LINCOLN CITY/LANCASTER COUNTY PLANNING STAFF REPORT

for March 30, 2005 PLANNING COMMISSION MEETING

P.A.S.: Tiedeman Acres Community Unit Plan
Co. Special Permit #05010, Preliminary Plat #05002

PROPOSAL: A community unit plan and preliminary plat for fourteen acreage residential units.

**SITE
PLAN**

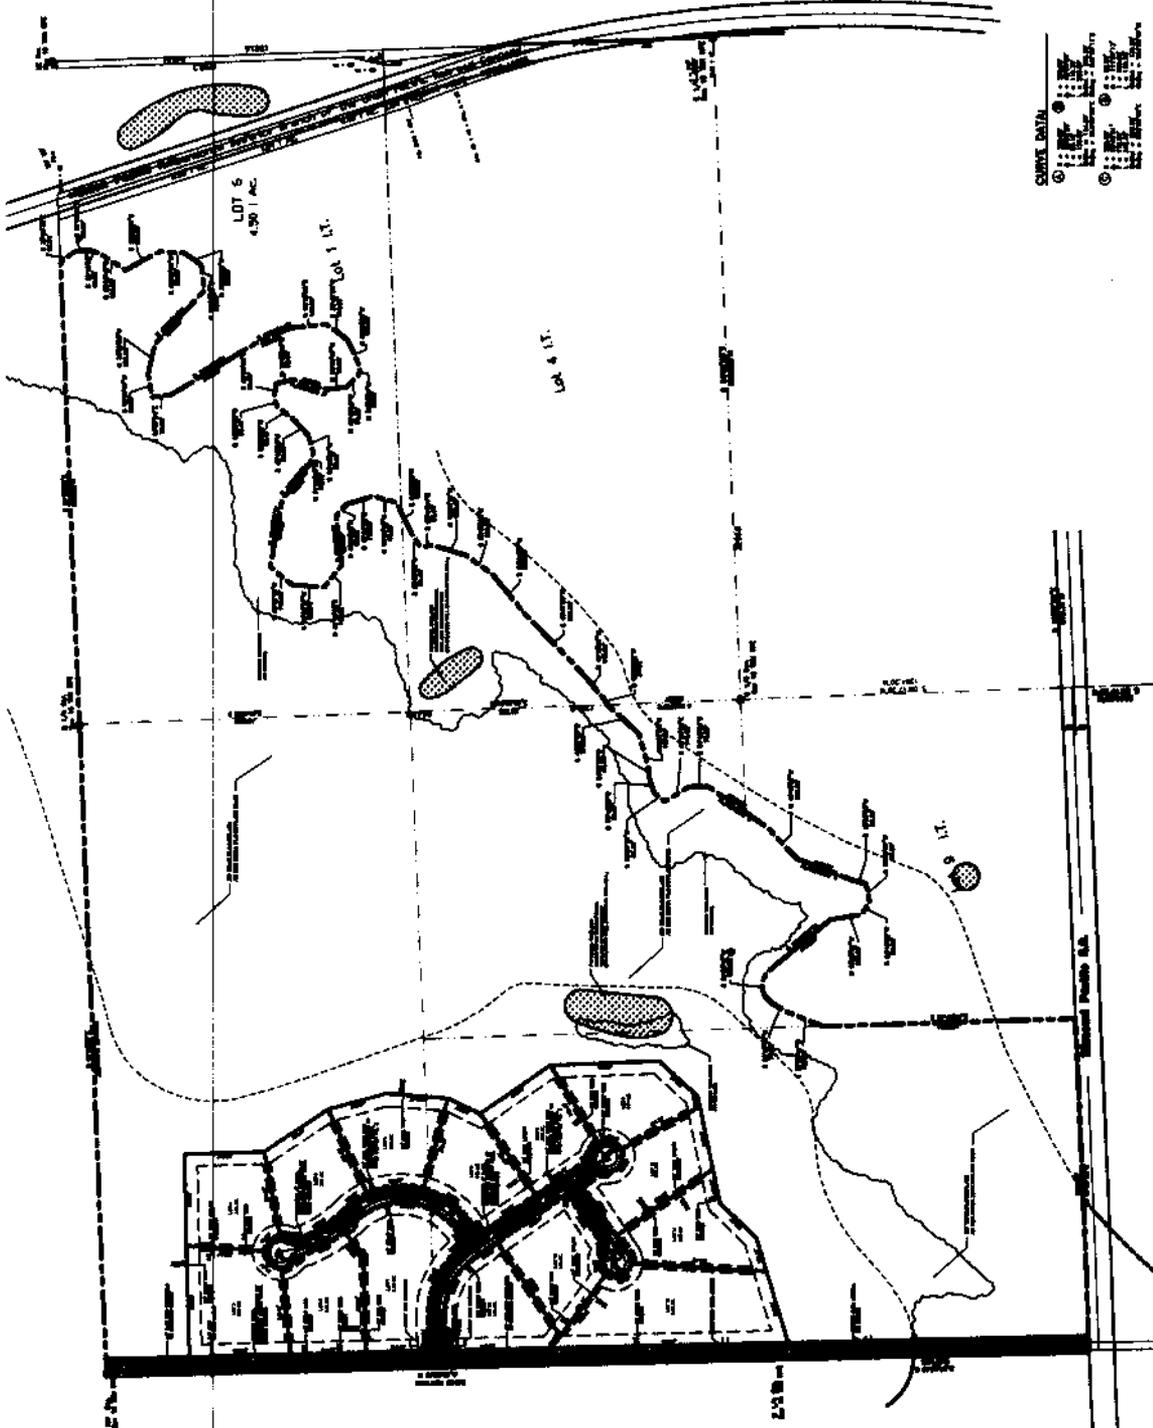
- 1.8 Show S. 26th Place extending to the north.
- 1.9 Show an extension of Krauter Place to the east.
- 1.10 Note the Outlot and its purpose.
- 1.11 Clearly show the 60' street dedication on S. 25th Street on sheet 2 of 3.
2. This approval permits 14 single family lots.

- 1.8 Show S. 26th Place extending to the north.
- 1.9 Show an extension of Krauter Place to the east.
- 1.10 Note the Outlot and its purpose.
- 1.11 Clearly show the 60' street dedication on S. 25th Street on sheet 2 of 3.

- 1) Dedication of 60.00 feet of right-of-way along South 25th Street is appropriate.
- 2) *General Note No. 11* shall be revised to relinquish access to South 25th Street except for an existing farm access to the outlot. No access to Lot 12 is allowed.

GRADING PLAN

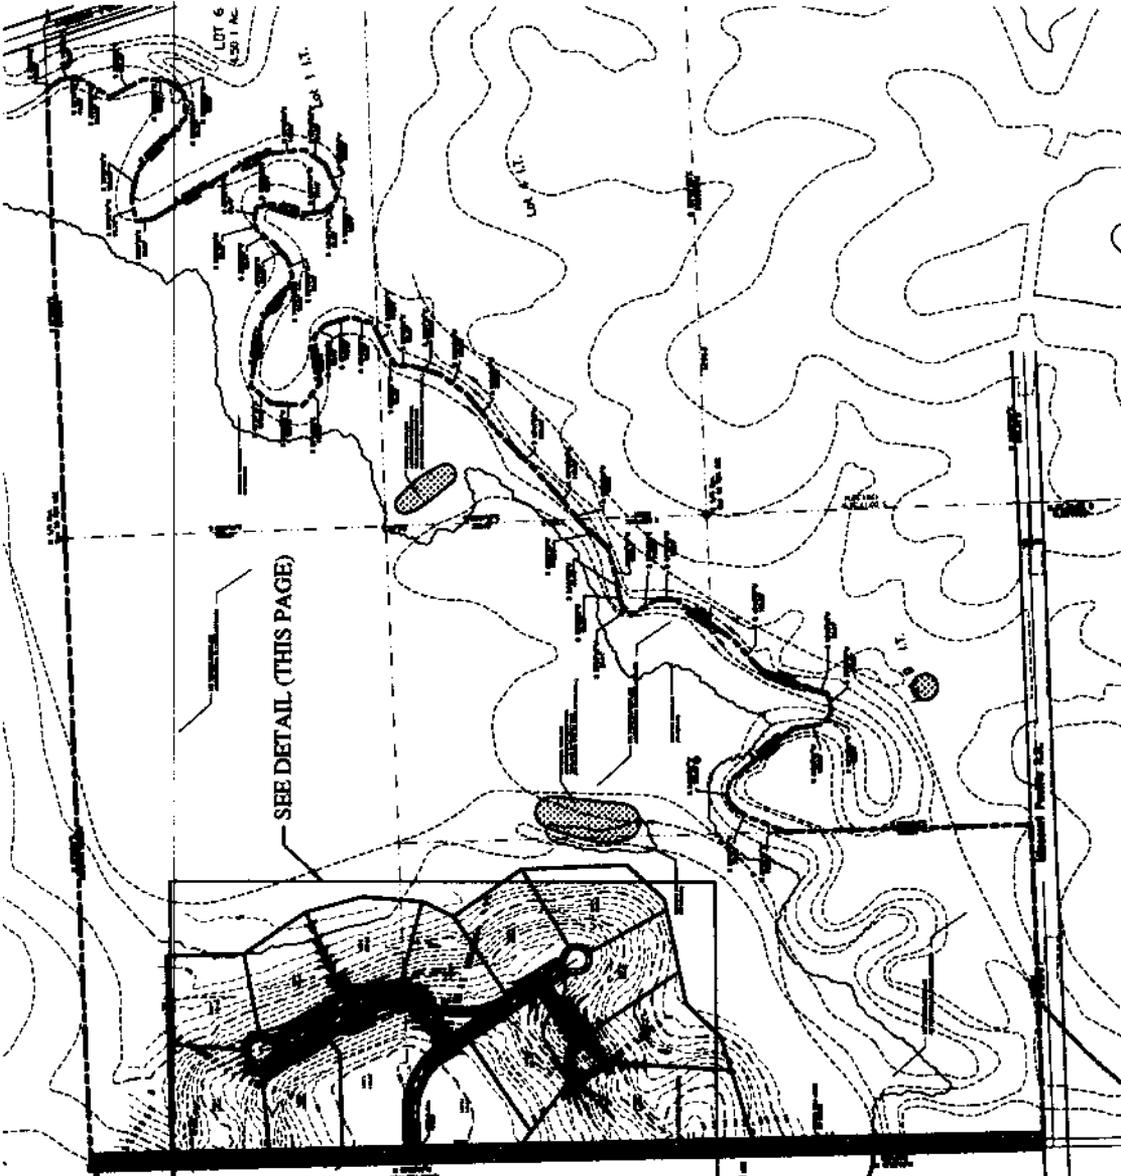
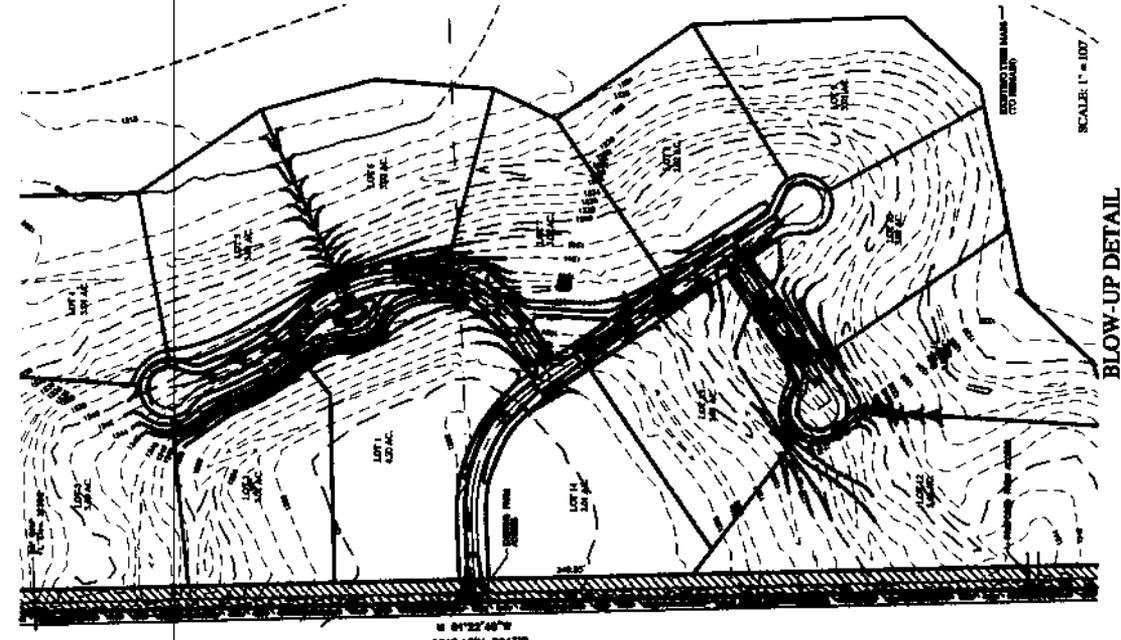
- 3) The sight distance on South 25th Street north of Krauter Place is not acceptable based on submitted profile. A "high point" in South 25th Street shall be re-graded or Krauter Place shall be relocated.

- 4) The profile of Krauter Place has a grade shown as 0.05% that should be 0.50%. Also there is no information shown for the P.I. near Station 5+00.
- 5) There should be grading contours shown around the cul-de-sac on Krauter Place.

- 6) South 26th Place should be extended to the north property line to provide for future development of adjacent property.
- 7) The culvert under South 26th Place is designed poorly with a deep depression on the inlet. Over time this depression will fill with silt and bury the inlet of the culvert.

- 8) A culvert should be added at the intersection of Reehl Place and Krauter place. Draining the road ditch from South 25th Street to the south side of the cul-de-sac of Reehl Place is too long.
- 9) Provide hydrology calculations for culverts.
- 10) The 100 year flood plain elevation detailed in *General Notes 20 and 21* is incorrect.
- 11) The developer shall provide the attached Exhibit B - Maintenance Responsibilities of Ditches and Drives - to all prospective buyers.
